# TOWN OF WEST SENECA

Please authorize the supervisor to execute the attached Change Order #3 to Resetarits Construction Company in the amount of \$60,591.48 for modifications, unforeseen conditions or improvements to the new West Seneca Community Center and Library based on the attached back up and quotes from the contractor.

<b>Date:</b> 07/25/2017	<b>RCC Job:</b> #16-010
<b>Project:</b> West Seneca Community Center & Library For Town Of West Seneca

<b>REQUEST FOR INFORMATION</b>	RFI #: 33
	Date: 02/10/17

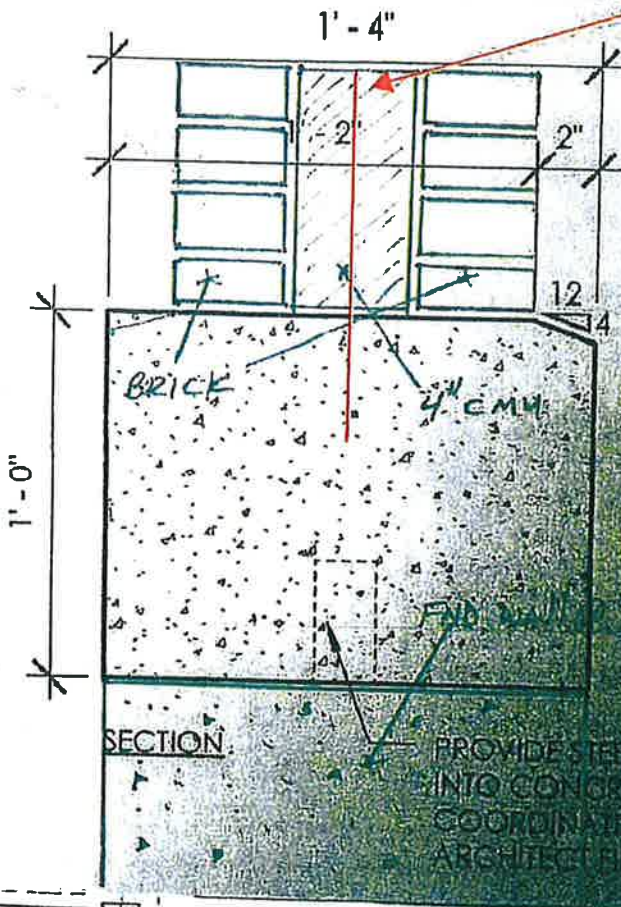
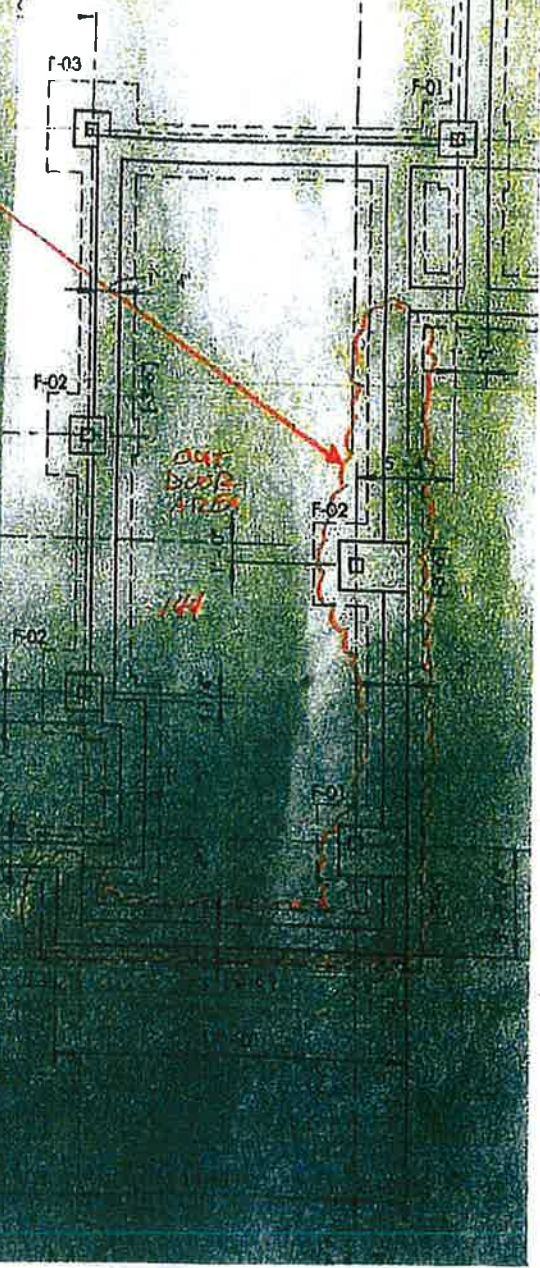
The attached sketch is acceptable with the following modifications:

- 1.) Provide #3 bar in the 4" CMU at 32" O.C.
- 2.) Grout all cores solid.
- 3.) Install truss-type horizontal joint reinforcing every 16" vertically tying brick wythes on opposite sides of CMU together.

#3 DOWELS @ 32" O.C.  
DRILL AND GROUT 4"  
INTO CONCRETE CAP.

PROVIDE STEEL  
INTO CONCRETE  
COORDINATE WITH  
ARCHITECT

THIS AREA WILL BE PRECAST  
PLANTER BASE PIECE PER A100  
23'-8"  
E RFI-24
